TECHNICAL SERVICE BULLETIN

MT88 Manual Transmission - No 3rd Gear And/Or Grinding Noise Going Into 3rd And/Or 4th Gear

23-2409

This bulletin supersedes 23-2219. Reason for update: Incorrect or Missing Parts

Figure 1

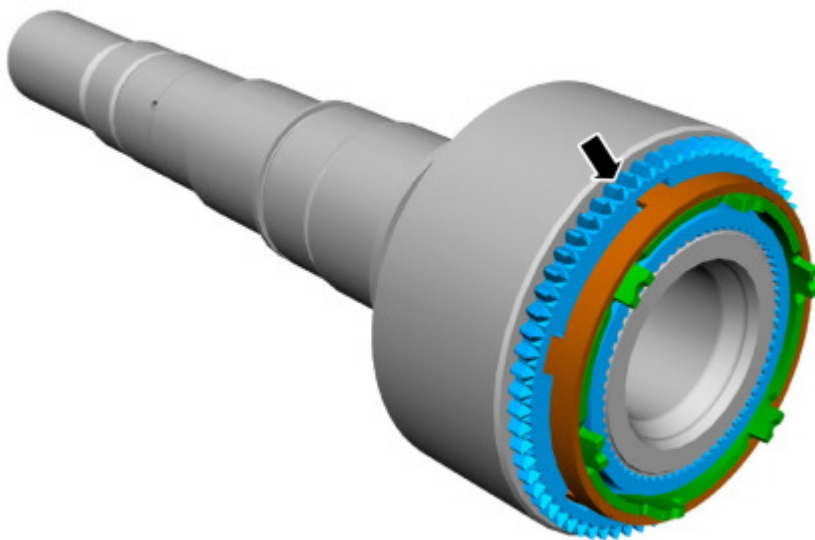
1. Remove the transmission from the vehicle. Refer to Workshop Manual (WSM), Section 308-03.
2. Disassemble the transmission. Refer to WSM, Section 308-03 > Disassembly > Transmission, Steps 1-34.
3. Remove the output shaft from the transmission case to gain access to the 3rd and 4th gears and synchronizer assemblies. Refer to WSM, Section 308-03 > Disassembly and Assembly of Subassemblies > Input Shaft, Steps 1-5.
4. Replace the following components and any associated damaged parts. Refer to WSM, Section 308-03.
 - 3rd gear.
 - Synchronizer assemblies for 3rd and 4th gears.
 - 4th gear synchronizer ring. (Figure 1)

- Inspect and replace any other damaged parts as needed.

NOTE: 3rd gear is part of the input shaft. The 4th gear assembly is part of the output shaft assembly and does not require replacement, unless damage is found. In this transmission 4th gear uses a synchronizer ring to align the synchronizer assembly with the gear during shifts.
